Technical Information
Valencia Spanish S-Tile Eave Closure
December 1, 2008

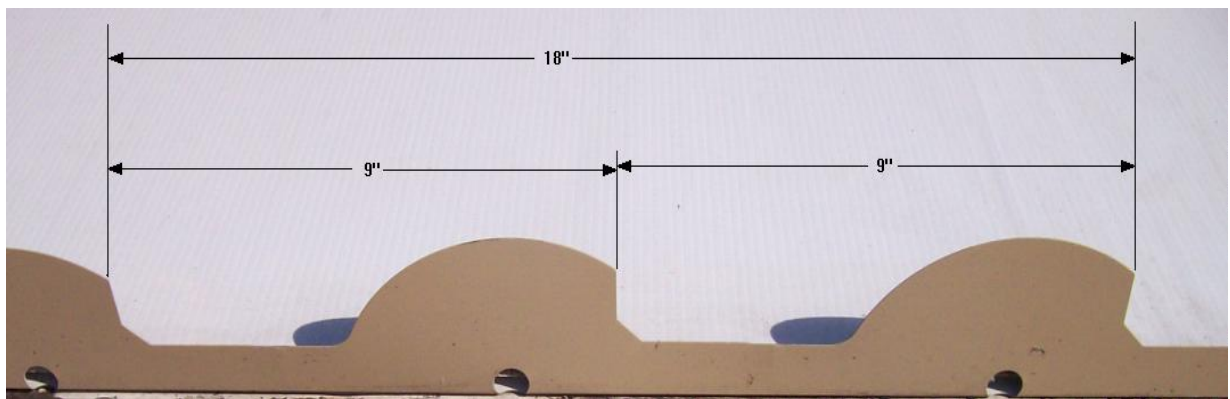
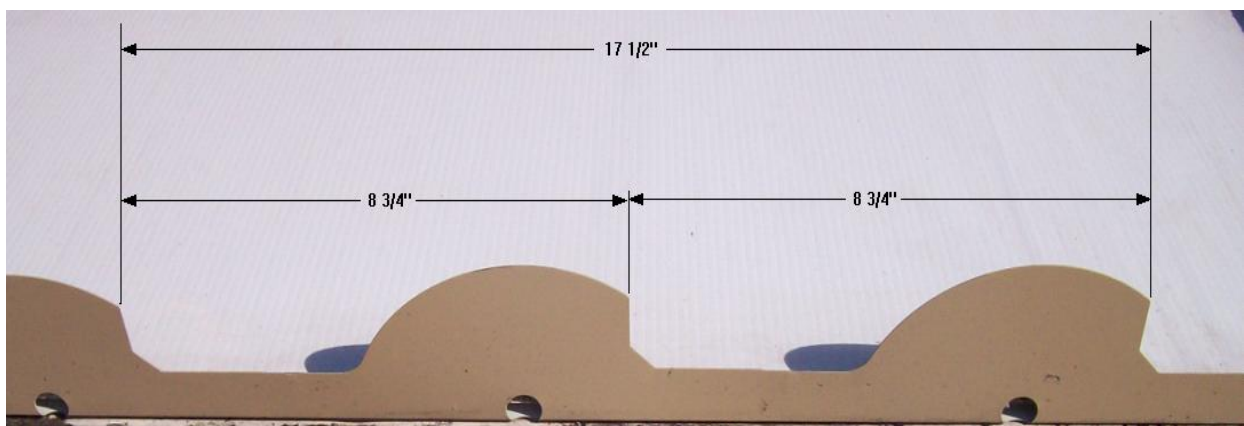
Our Valencia Spanish-S eave closure previously had a pitch of 9" from tile to tile. See detail # 1. The eave closure being supplied today is now being produced using an 8 ¾" spacing from tile to tile. This requires that when snapping the vertical lines on the roof deck for installation of the field tile (every other vertical course) the spacing should be, 17 ½ inches. See detail # 2.
